RE: NHTSA Recall 04V114000

Addendum to Recall Campaign #90

AFFECTED: 2000-2004 Winnebago and Itasca P-series models covered under Recall Campaign 90 – Addition of LP Gas Tank Mounting Cradle Brackets

SUBJECT: Alternate LP Tank Straps

**Old Tank with Black Pipe 'T' and Regulator toward Rear of Coach
Disconnect black pipe from elbows at both ends and flip 180° for new tank as shown below**

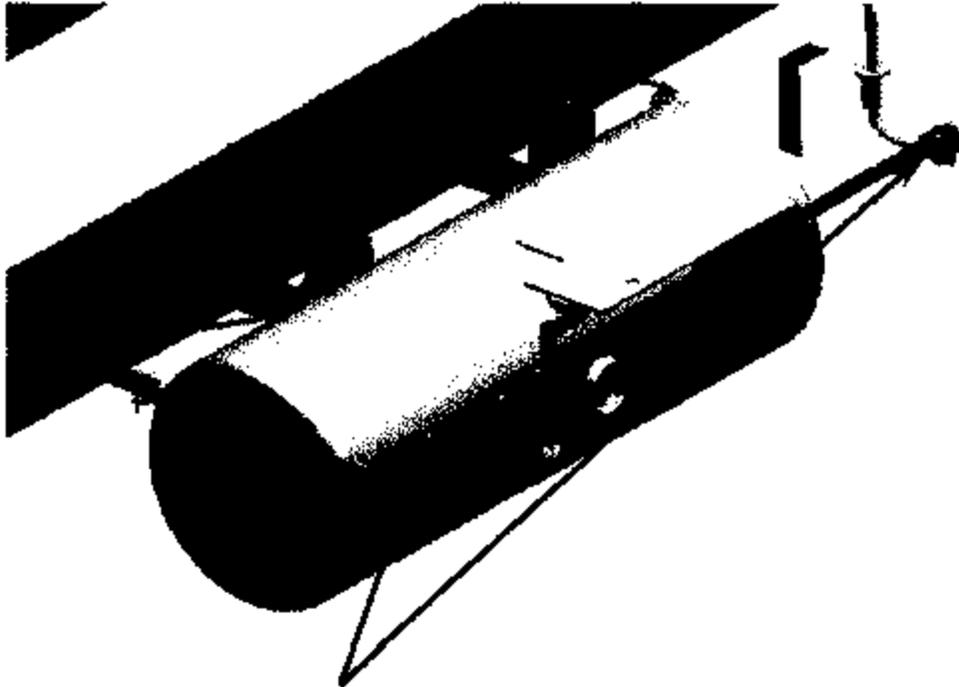
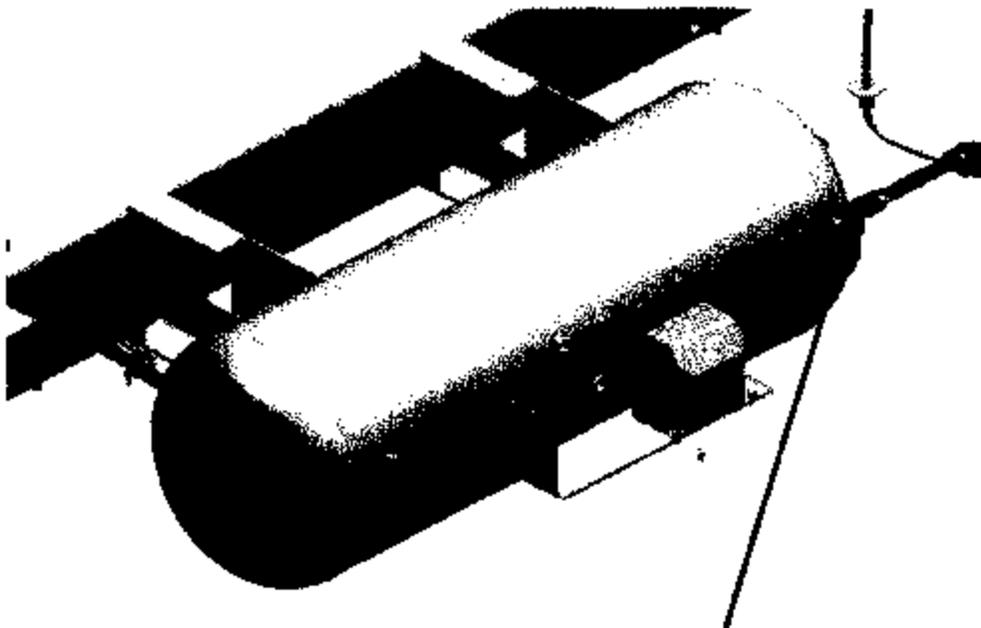
If a tank replacement is necessary, you may also need to 'swap ends' of the LP gas supply black pipe to adjust the location of the 'T' fitting and hose to the gas regulator as shown in the illustrations below. Always use approved thread sealer and conduct a leak test on new connections.

New Tank with Black Pipe 'T' and Regulator toward Front of Coach
